C01	ISSUEDFORCOMMENT	15.06.2022
REVMARK	REVISIONDESCRIPTION	REVISIONDATE

DRAWINGTITLE	GATE2TOWNHALLSQUARE	
CONTRACT	HORNSEYTOWNHALL	
MODELLEDBY	IT	DATE 13.06.2022
CONTRACTNO	SELI 1 42	SCALE 1:5 1:10 1:12.5
DRAWINGNo	741 4-10-007	REVISIONNo. C01

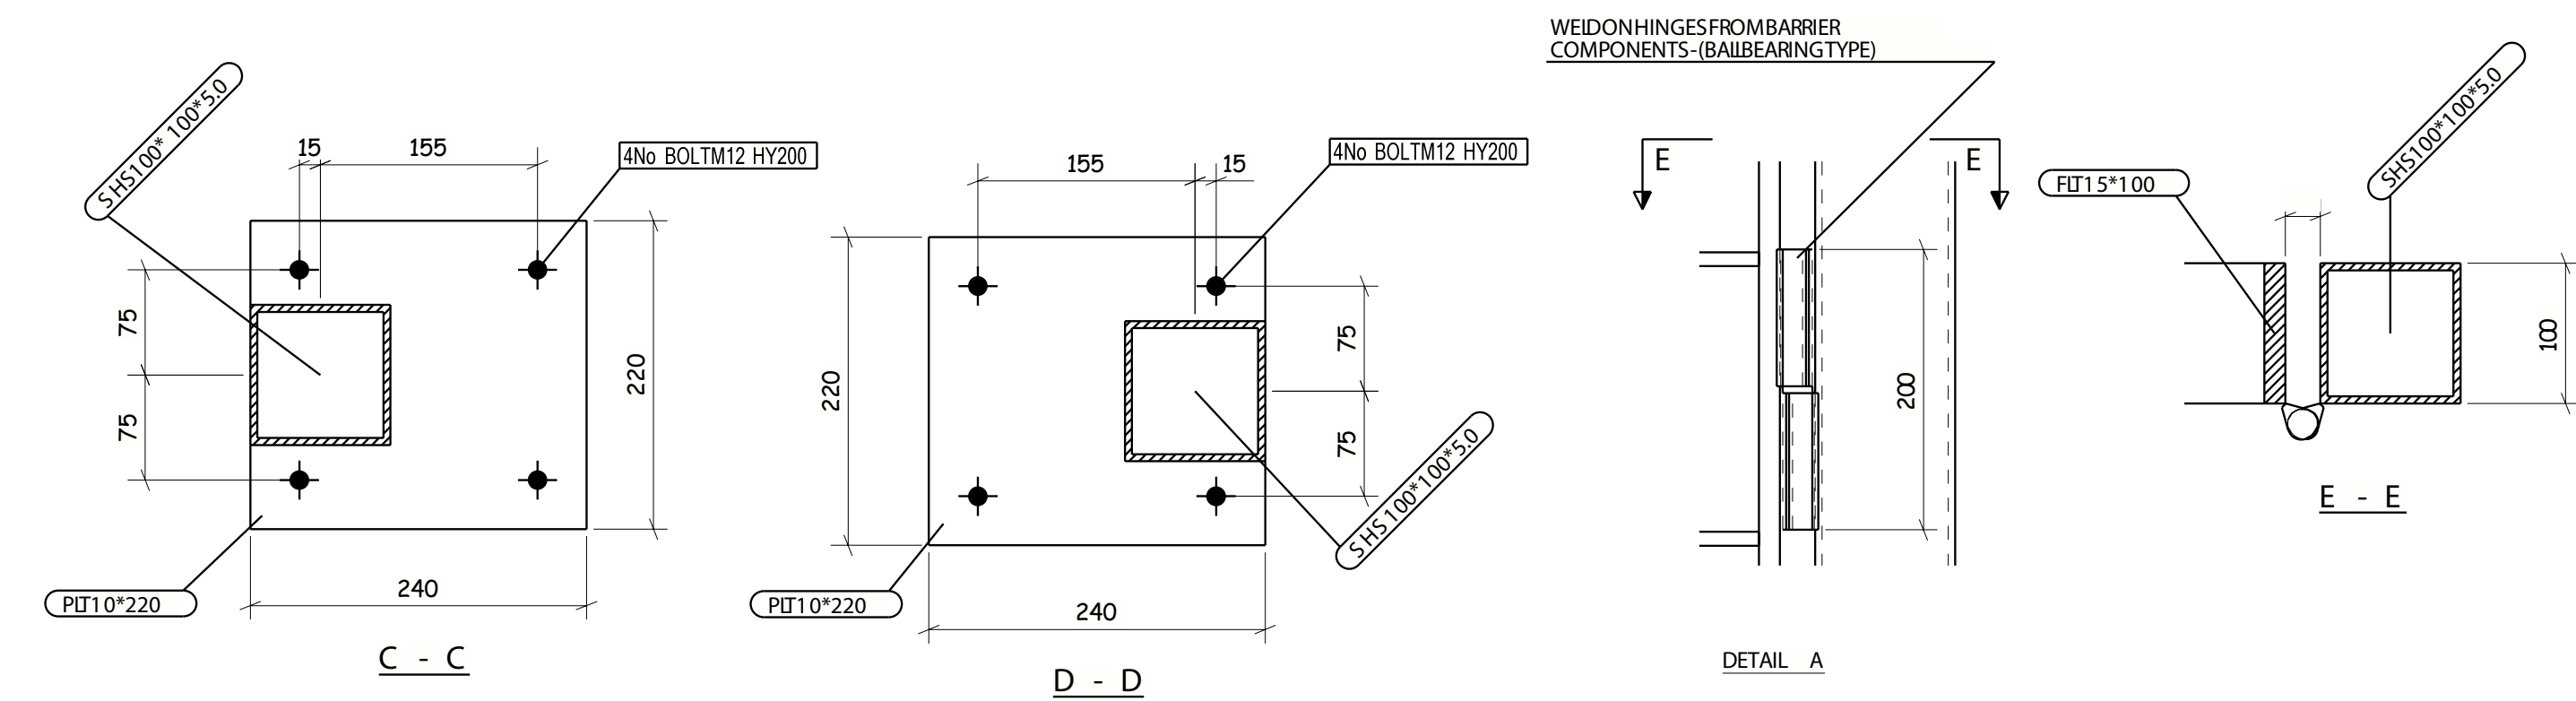
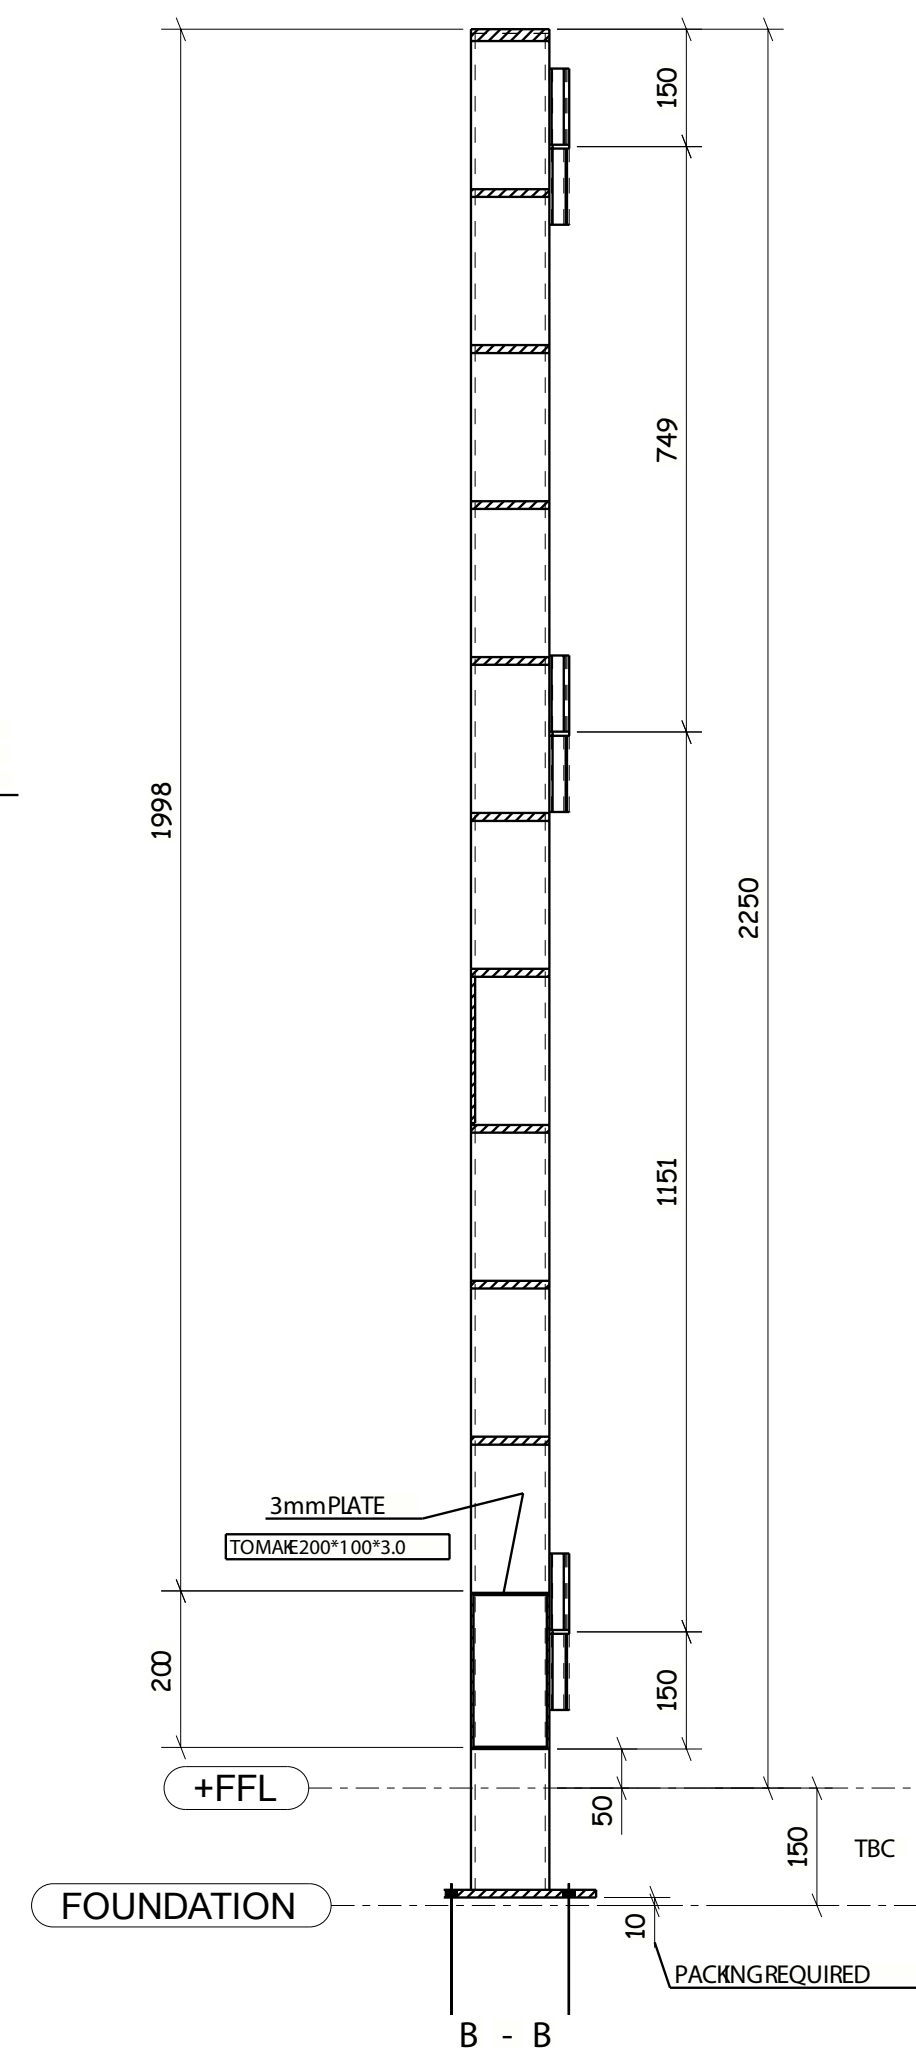
FURTHERDETAILS WILLBE REQUIREDREGARDSHOWTHE GATESWILLBEHIDCLOSED-ATTHEMOMENTTHEREIS NOGATESTOPSHOWN.

CANAHEADBEAMBEINSTALLEDABOVETHEGATESTO ENABLEMAGLOCKSTOBEINSTALLED?
